WARRANTY
CAMPAIGN

ROADSTER
WARRANTY
Bulletin

Subject: **Spyder™**

No. **2013-9**

1. Old fuse box cover
2. New fuse box cover

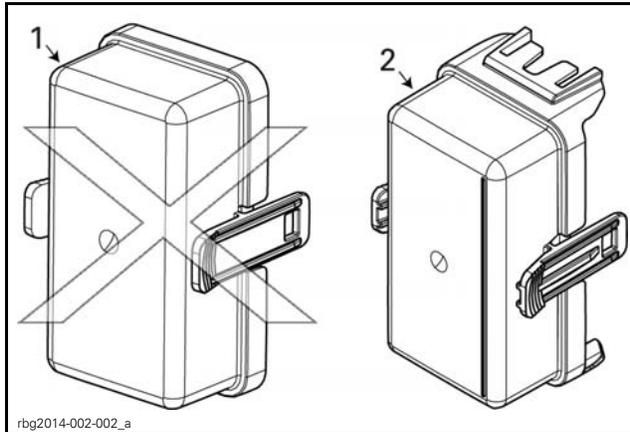
Water may infiltrate either of the front fuse boxes. The source of the infiltration may be:

1. The fuse box cover.
2. The bus-bar connection behind fuse box
3. Any of the wire splices behind fuse box.

1. Replace the fuse box covers.
2. Apply liquid tape around base of bus-bar.
3. Apply liquid tape into and around all splices behind fuse boxes.

Repeat procedure for each fuse box.

TYPICAL LIQUID TAPE APPLICATION

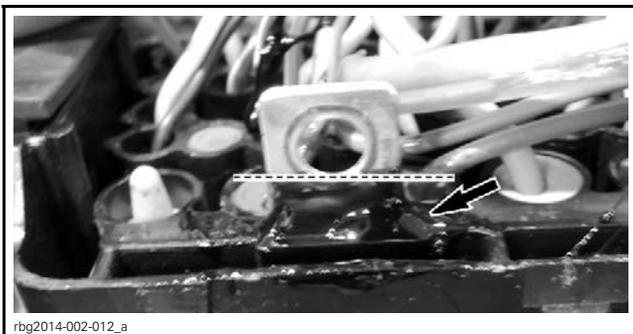
4. Remove electrical tape as needed to expose all wire splices behind the fuse box.

5. Seal both ends of all the wire splices with liquid tape.

NOTE: Extend liquid tape onto wires and push the liquid tape into both ends of the splice for a good seal.
